Technical Bulletins Sorted By Bulletin Number
Generated 12/31/92

BULLETIN NO.: I/O:02

PRODUCT: 26-1171 Telephone Interface II

Figure 1

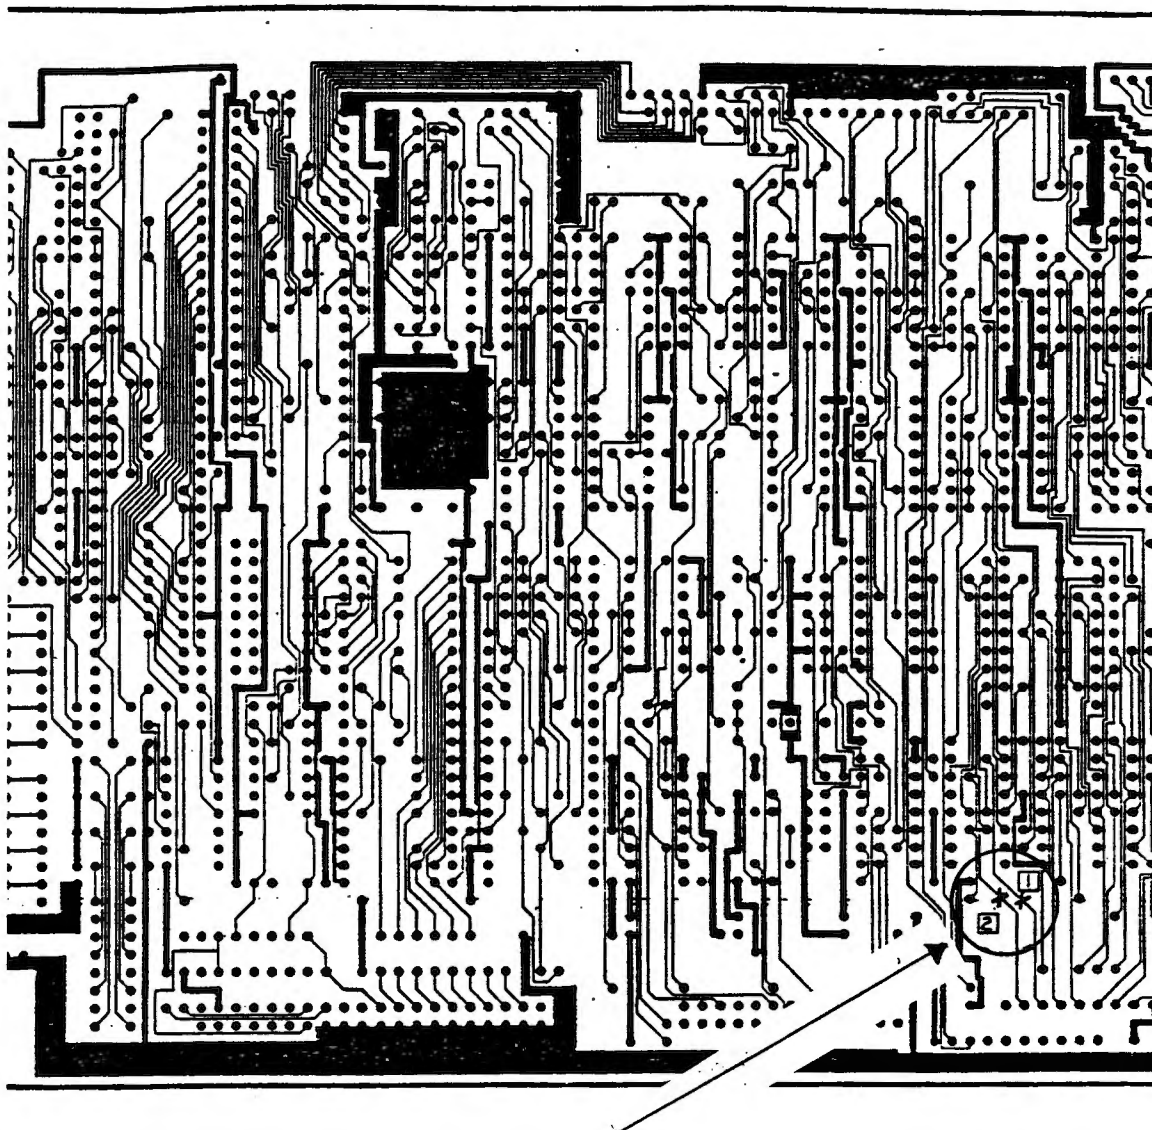
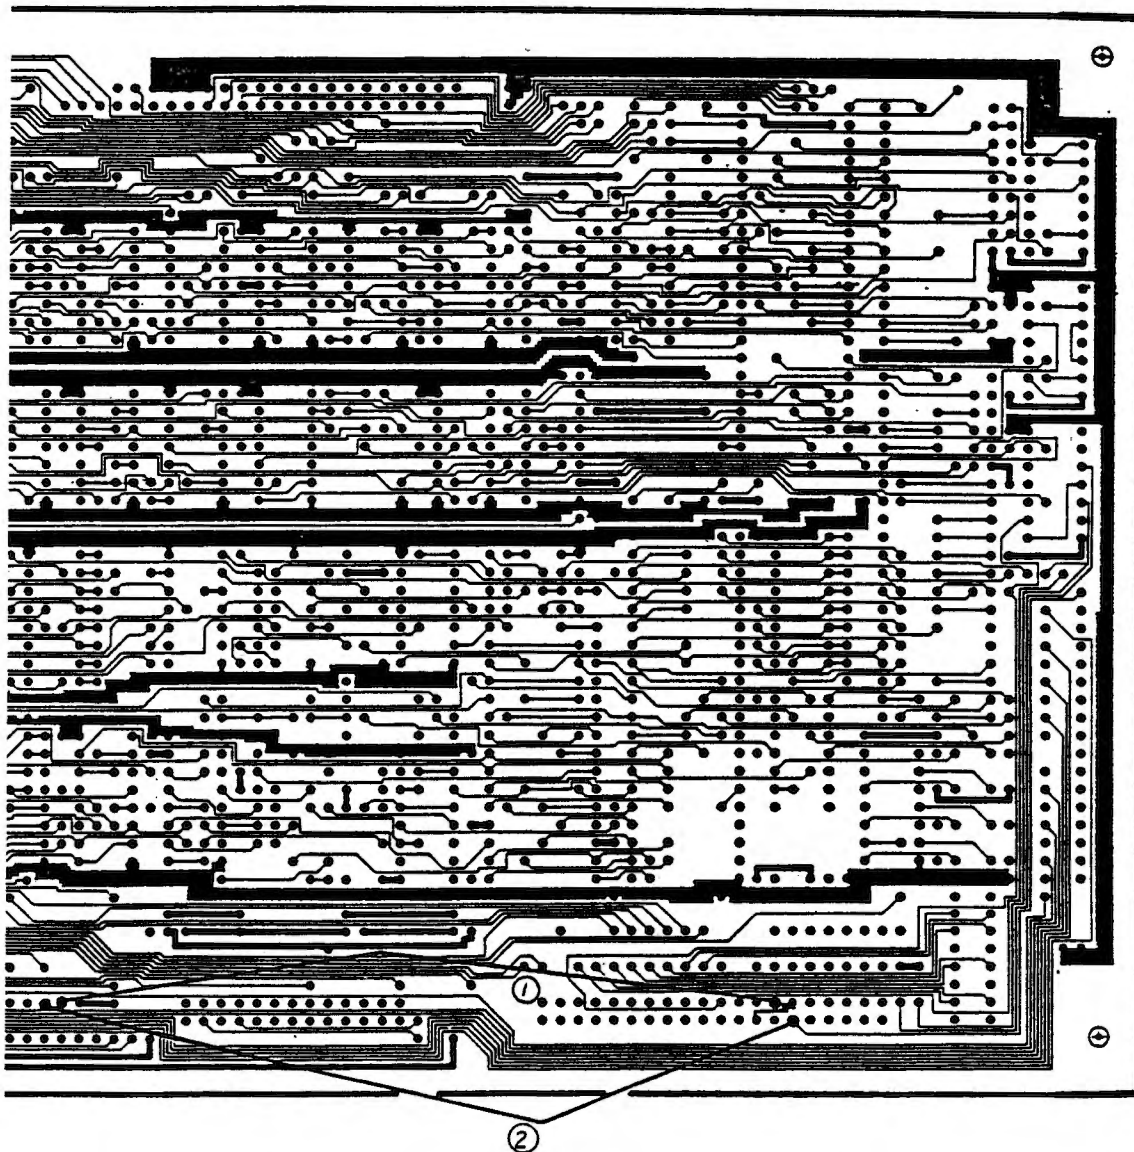
Make the following cuts on the component side of the board (Refer to Figures 1 and 3):

Cut the trace going from IC97 pin 10 to IC106 pin ~~X~~.3
Cut the trace going from IC97 pin 6 to IC106 pin ~~X~~.2

1. Cut the trace going from IC97 pin 10 to IC106 pin ~~2~~ 3
2. Cut the trace going from IC97 pin 6 to IC106 pin ~~1~~ 2

Figure 3

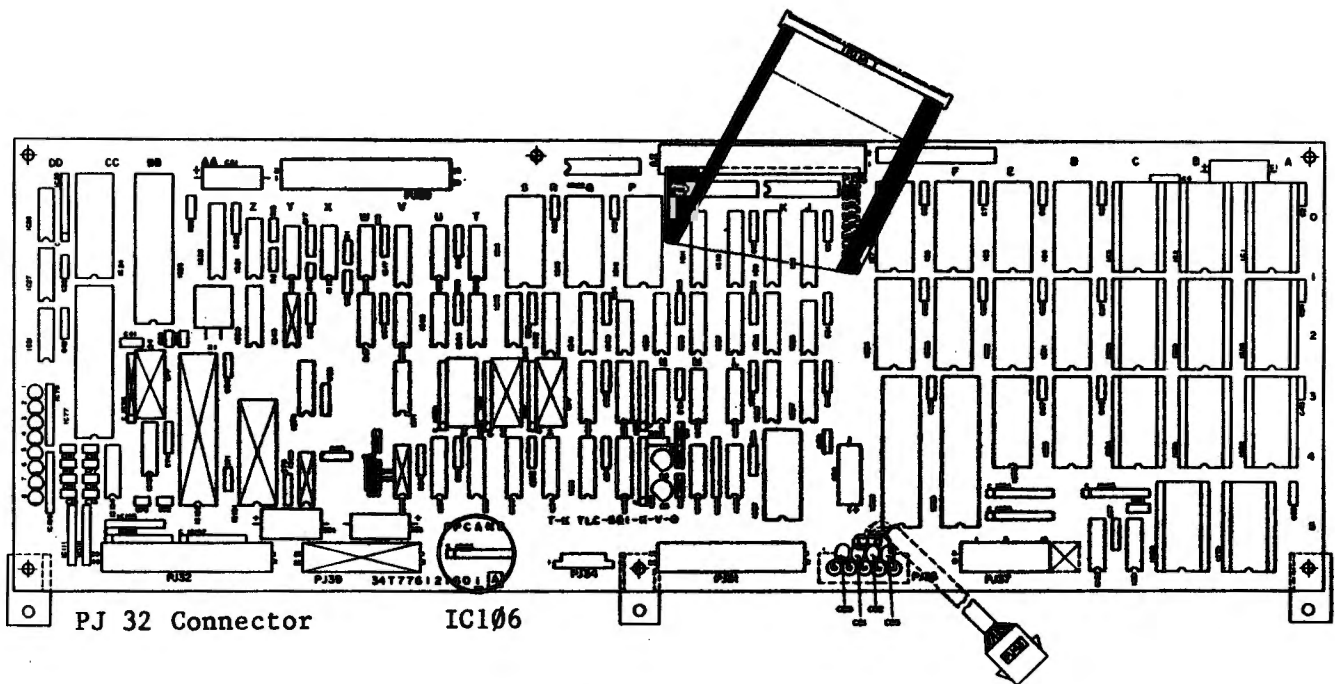
Jumper the following points on the foil side of the board (Refer to Figures 2 and 3):

1. Jumper PJ32 pin 27 to IC106 pin ~~X~~ 2
2. Jumper PJ32 pin 30 to IC106 pin ~~X~~ 3

Figure 2

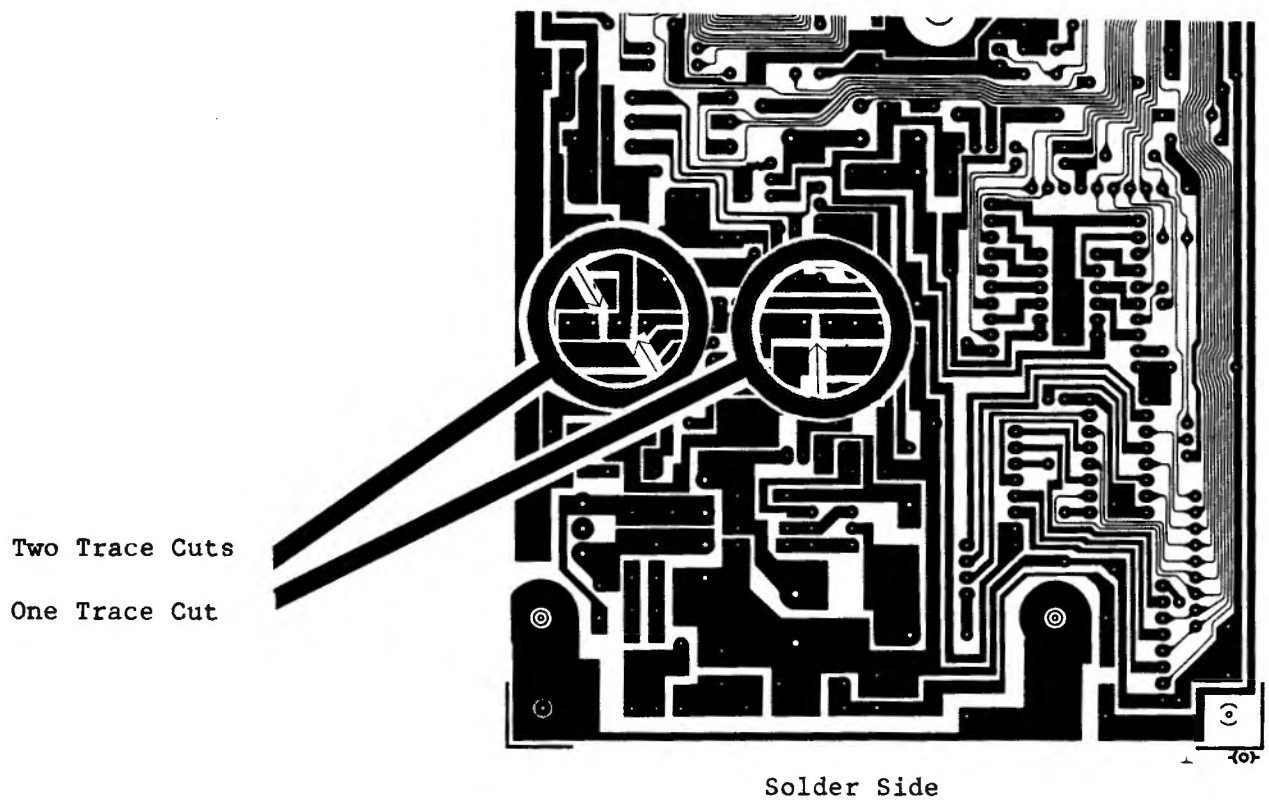
- 2.) Locate and remove the two transistors labeled Q9 and Q11. If these are not 2SA1598 components they will need to be replaced.
- 3.) Three trace cuts will need to be made on the solder side of the logic board. Two of the cuts are on one of the solder pads for L1 and the final cut is on one solder pad for L2. Reference figure 2 to see where these cuts are made.

Figure 3

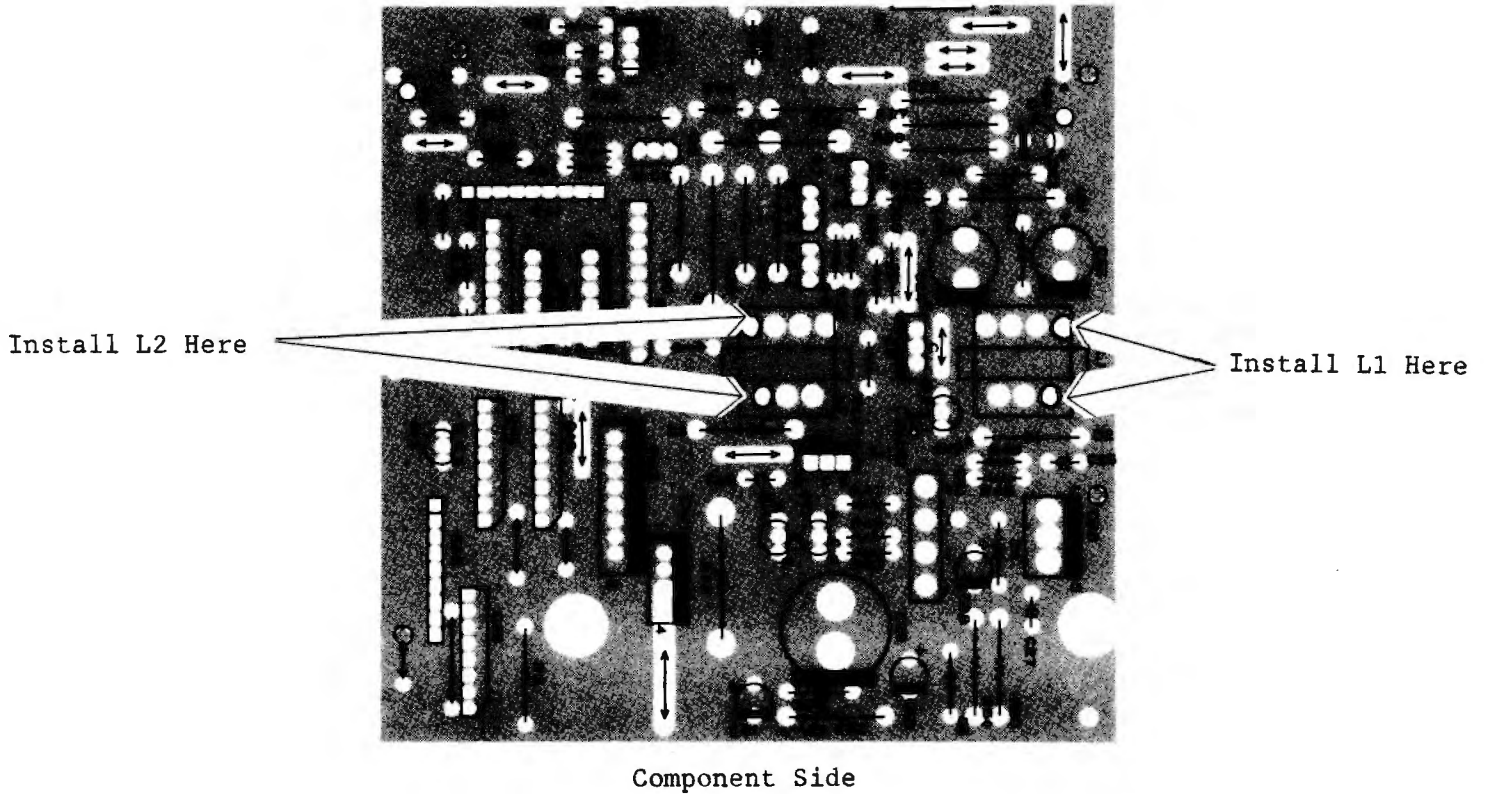
- 4.) Install one of the round style inductors at location L1 in the holes closest to the outside edge of the board. See figure 3.
- 5.) Install the second round style inductor at location L2 in the holes closest to the middle of the board. See figure 3.

Figure 5

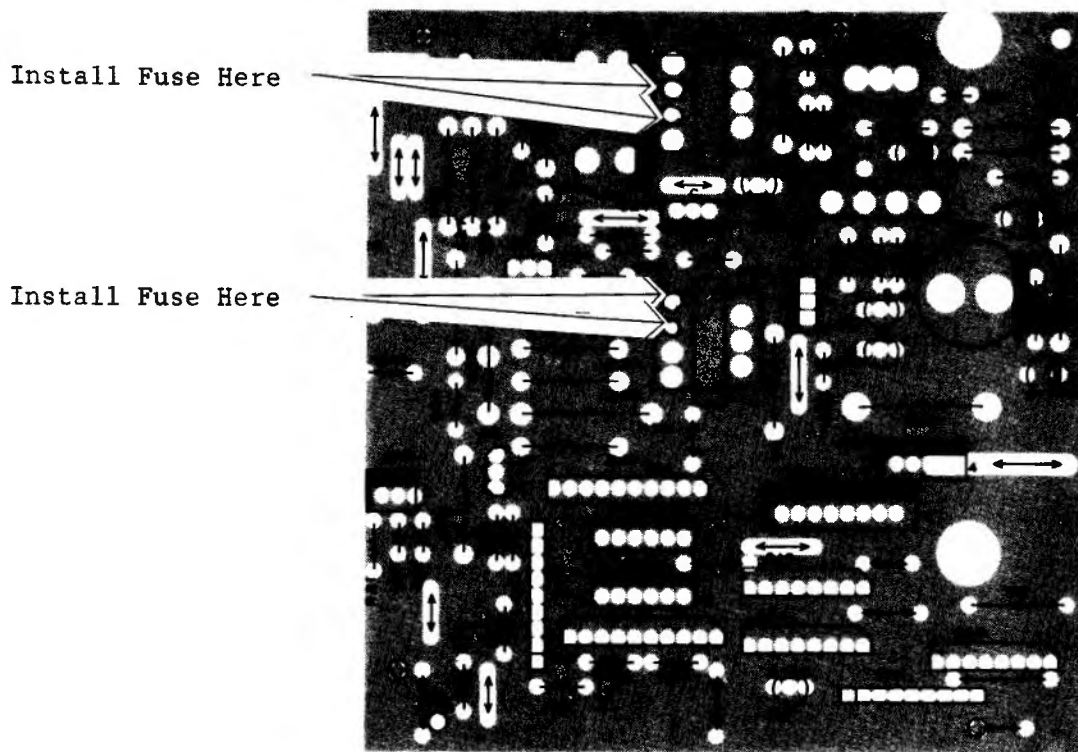
- 8.) Install one of the 1.5A fuses into the center two pins at L1. Install the other 1.5A fuse in the two pins at L2 which are closest to R36. See figure 5.

Figure 6

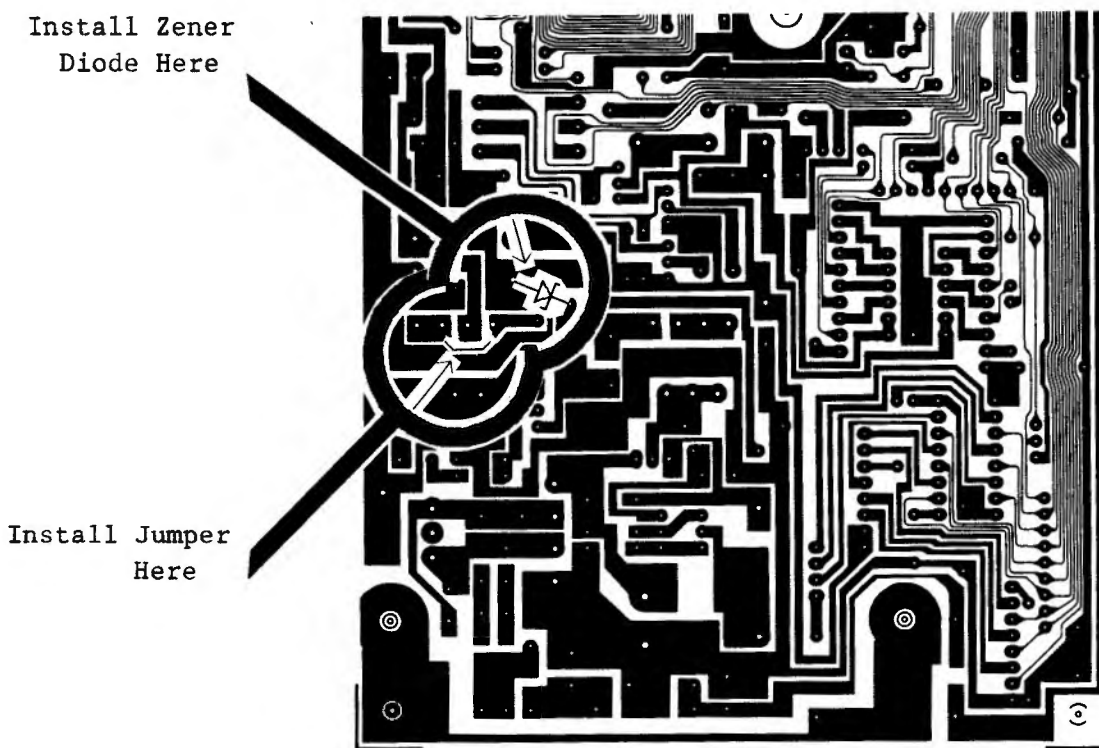
- 9.) On the solder side of the circuit board a jumper must be added. Locate the remaining hole on the solder pad for L1. This hole has a trace that leads to Q10 the 78L05 voltage regulator. Jumper from this point to the pad connecting coil L1 and the fuse using insulated wire of 20-22 GA. See figure 6.

- 10.) On the solder side of the circuit board a 27 volt zener diode must be added between the emitter of Q9 and ground with the cathode on the emitter. See figure 6.

Figure 2

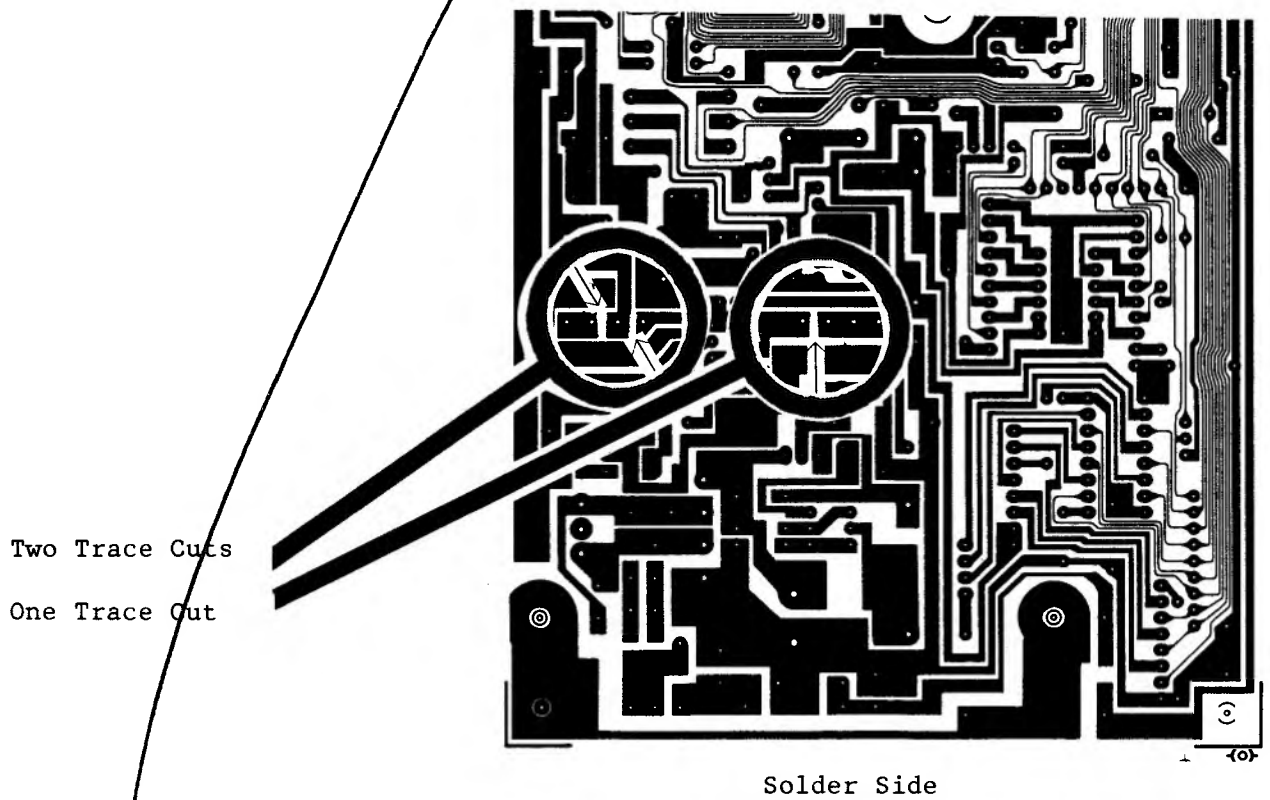
- 2.) Locate and remove the two transistors labeled Q9 and Q11. If these are not 2SA1598 components they will need to be replaced.
- 3.) Three trace cuts will need to be made on the solder side of the logic board. Two of the cuts are on one of the solder pads for L1 and the final cut is on one solder pad for L2. Reference figure 2 to see where these cuts are made.

Figure 3

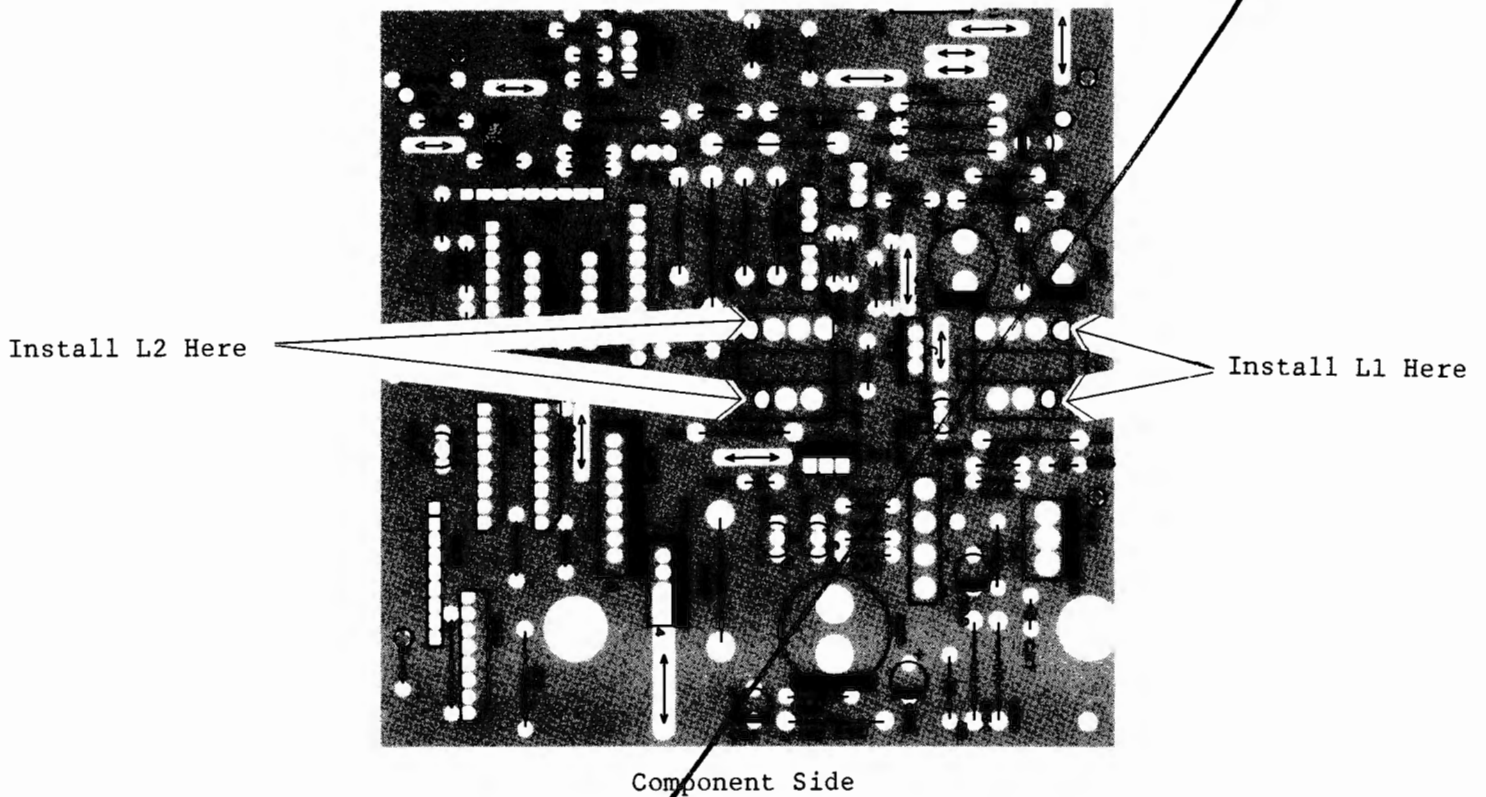
- 4.) Install one of the round style inductors at location L1 in the holes closest to the outside edge of the board. See figure 3.
- 5.) Install the second round style inductor at location L2 in the holes closest to the middle of the board. See figure 3.

Figure 5

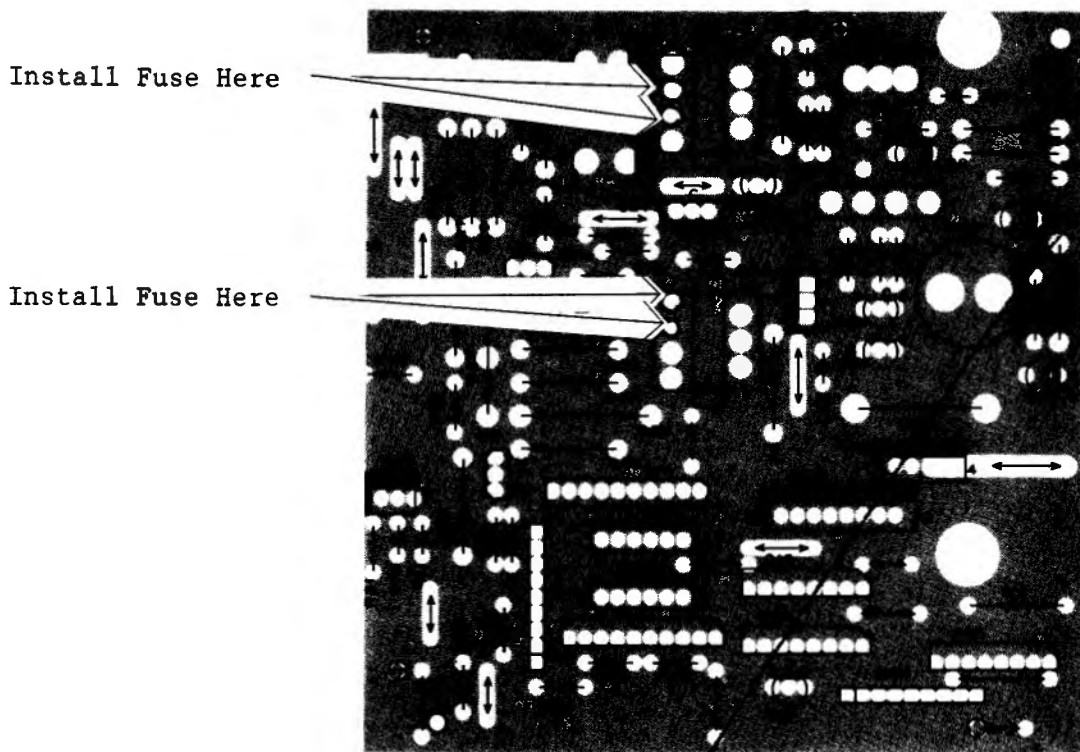
- 8.) Install one of the 1.5A fuses into the center two pins at L1. Install the other 1.5A fuse in the two pins at L2 which are closest to R36. See figure 5.
